Engineering Change Order

ECO# <u>7228</u>	DWG.#/ITEM# <u>74298</u>
Requested by: <u>ERIC</u>	CSC#: <u>P37</u> JOB #: <u>079832N</u>
Department: <u>CSC 37</u> Date: <u>8/2/98</u>	Date Effective: <input checked="" type="checkbox"/> Immediate <input type="checkbox"/> Phase In <input type="checkbox"/> Record Only
Request Approved by: <u>CL</u>	Changed By: <u>CYL</u>
Date: <u>8/2/98</u>	Date: <u>8/2/98</u>

CLAMPS & ENCLOSURES

Crunch Ring Strongback Analysis

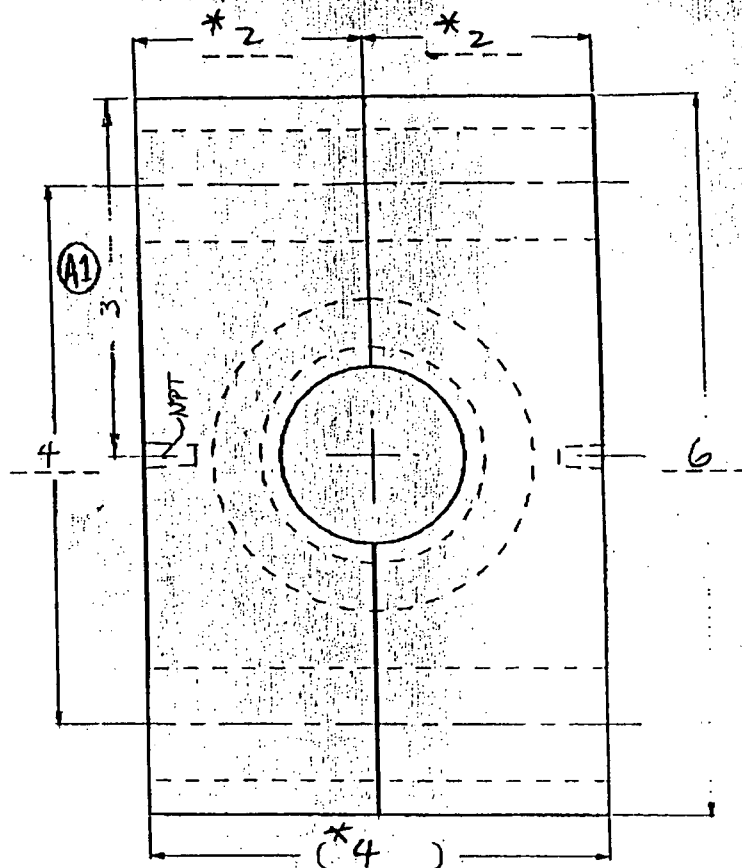
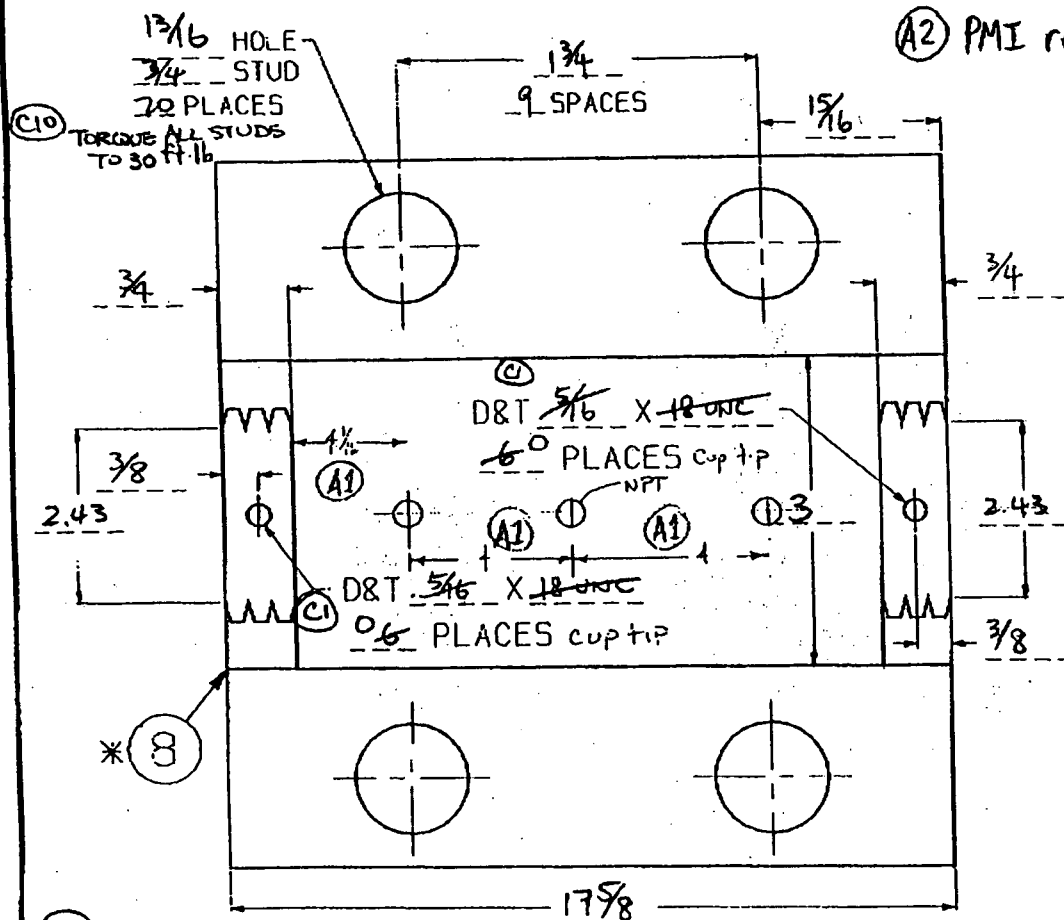
Description of Change: ~~CHANGE SIZE & # OF SET SCREWS~~
 DUE TO NOT INJECTING ENCLOSURE
 VOID SET SCREWS
 MOD CLAMP TO ACT AS CRUNCHRING.

(C6) DO NOT INJECT
~~LIMIT MAX INJ. PRESSURE TO 1100 PSI STATIC~~

(C5) MIN 1/16" FROM
SPLIT LINE (EACH HALF)

Sheet 7a of 9

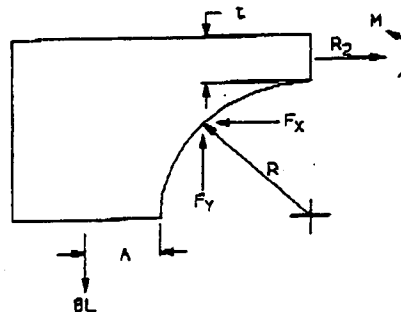
Purpose: This analysis will calculate the frictional force caused by the Crunch Ring Strongback and the internal stresses of the Crunch Ring Strongback due to the bolting.

Friction Force of Crunch Ring Strongback

$$F_f = 22320.098 \cdot \text{lb}f$$

Greater Than

$$T_h = 8506 \cdot \text{lb}f$$

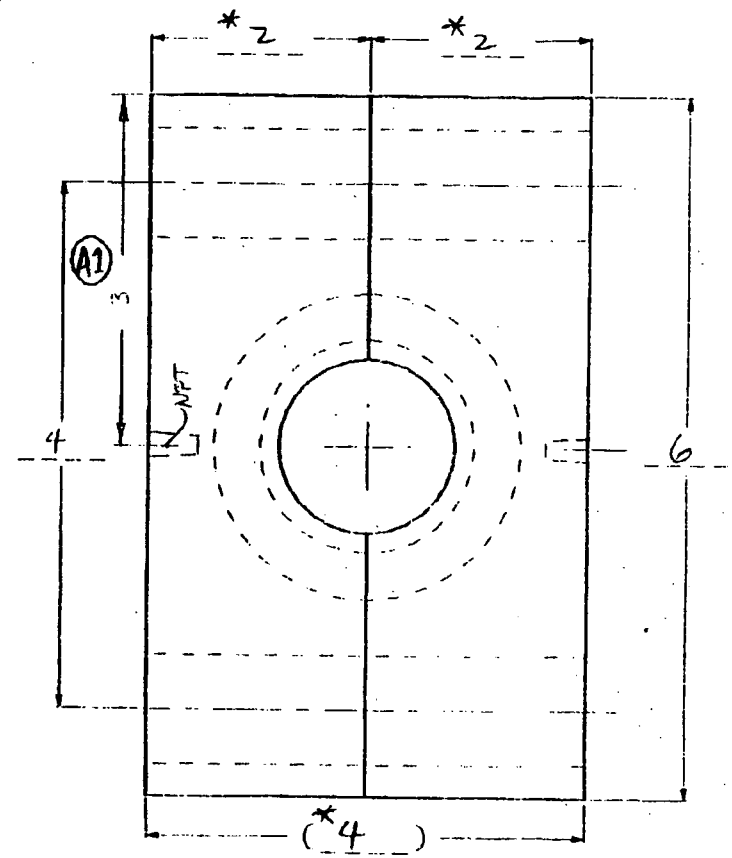
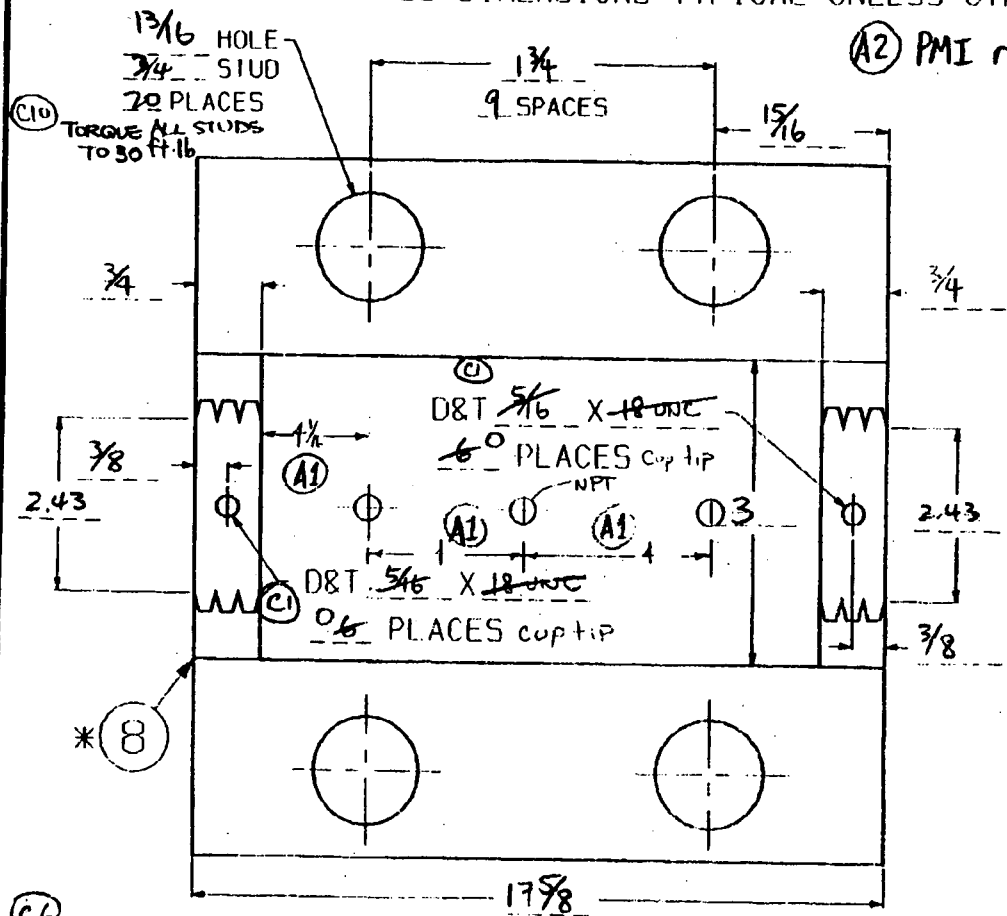
(C6) DO NOT INJECT
~~LIMIT MAX INJ. PRESSURE TO 1100 PSI + STATIC~~

(C5) MIN 1/16" FROM
SPLIT LINE (EACH HALF)
* DIMS BEFORE MILL
"CONFIDENTIAL"
PROPRIETARY INFORMATION

Proposed Clamp Design
Figure 3

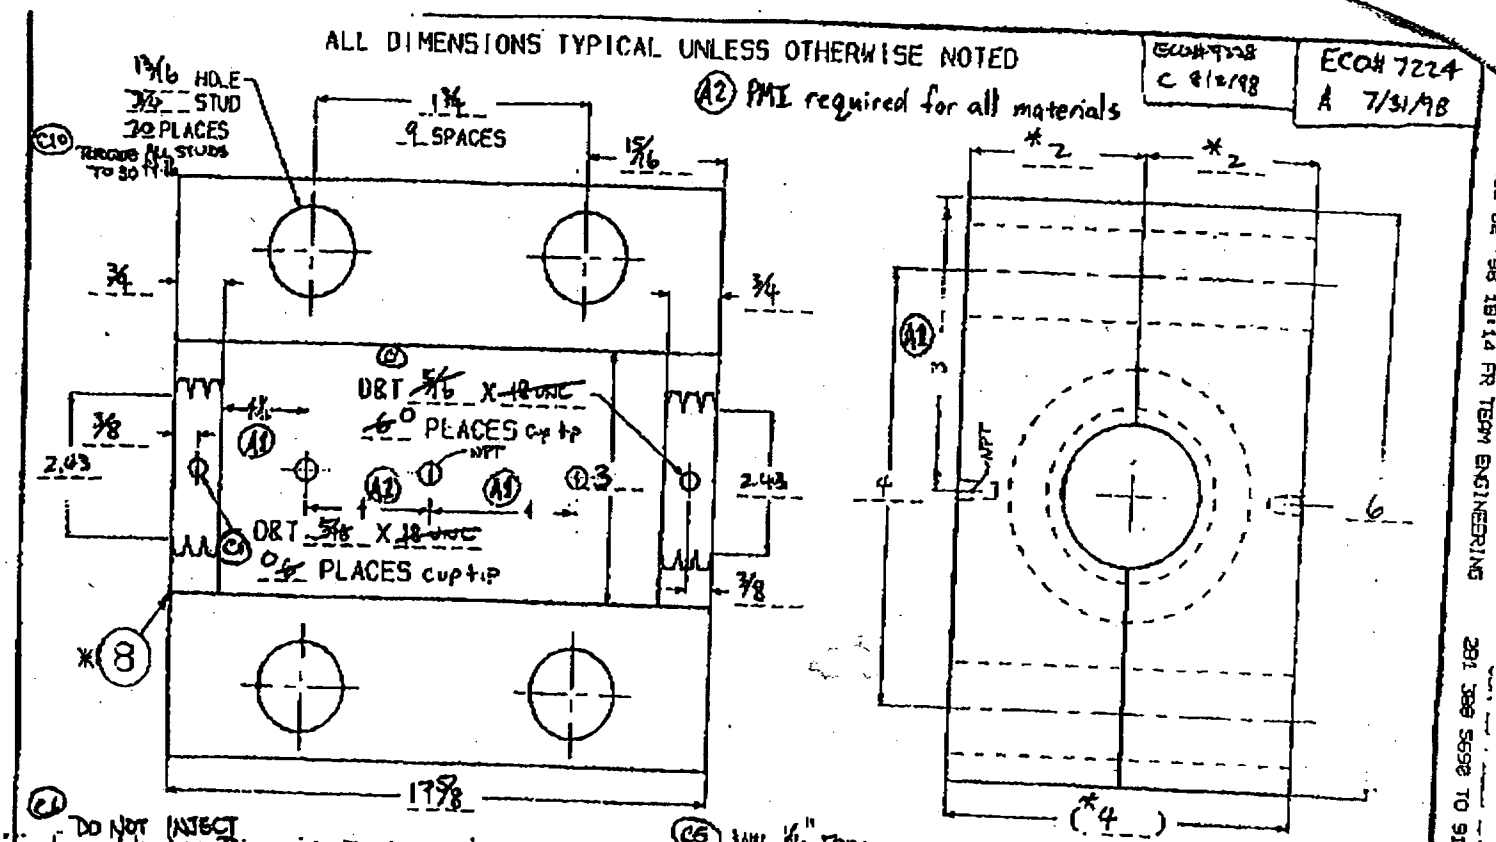
(A1) DO NOT INTERFERE WITH MAX. PRESSURE TO HOOPER STATE

(A2) WILL 1/16" FROM SPLIT LINES (EACH HALF) * DIA. BEGINS WILL
